# Access Compliance Report

## Public Rights-of-Way (Curb Ramps)

Intersection ID: 14828	Main Street: DWIGHTWARE_BV	Cross Street: SHACKLEFORD_TR	Location: NE
ADA ID: E63C9E618F47	Ramp Type: Directional1	Initial Pass/Fail: Fail	Overall Compliance: No
			Severity Score: 13.75

### Codes/Mitigation Info/Possible Solution

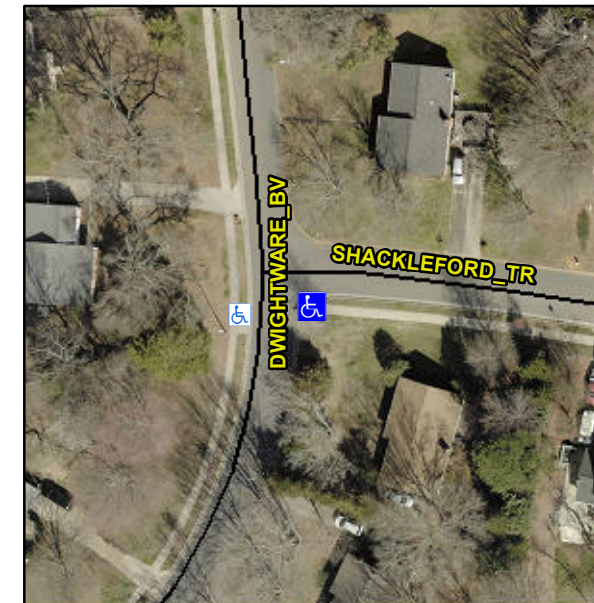
**R304.2.2**

Compliance	Description	Data	Compliance	Description	Data
N/A	Ramp Length (in)	84.0	N/A	Grade Break?	N/A
Yes	Ramp Width (in)	48.0	N/A	Grade Break Slope (%)	0.0
No	Ramp Slope (%)	10.5	N/A	Grade Break XSlope (%)	0.0
Yes	Ramp XSlope (%)	4.0			
N/A	Flare Type LT	N/A	N/A	Flare Type RT	N/A
N/A	Flare Slope LT (%)	N/A	N/A	Flare Slope RT (%)	0.0
N/A	Flare Traversable LT?	N/A	N/A	Flare Traversable RT?	N/A
N/A	Landing Length (in)	0.0	N/A	DWS Provided?	N/A
N/A	Landing Width (in)	0.0	N/A	DWS Contrast?	N/A
N/A	Landing Slope (%)	0.0	N/A	DWS Length (in)	N/A
N/A	Landing X Slope (%)	0.0	N/A	DWS Full Width?	N/A
N/A	Landing Curb? (Y/N)	N/A	N/A	DWS Offset LT (in)	N/A
N/A	Shared Landing?	N/A	N/A	DWS Offset RT (in)	N/A
N/A	Gutter Ponding?	0.0	N/A	Gutter Slope (%)	N/A
N/A	Gutter Lip Ht (in)	0.0	N/A	Gutter X Slope (%)	N/A
N/A	Painted X Walk1?	No		Road Slope (%)	0.5
	X Walk 1 Direction	To W		Road X Slope (%)	4.3
	X Walk 1 Width (in)	N/A		Clear Space?	N/A

**Remove & Replace Entire Ramp.**
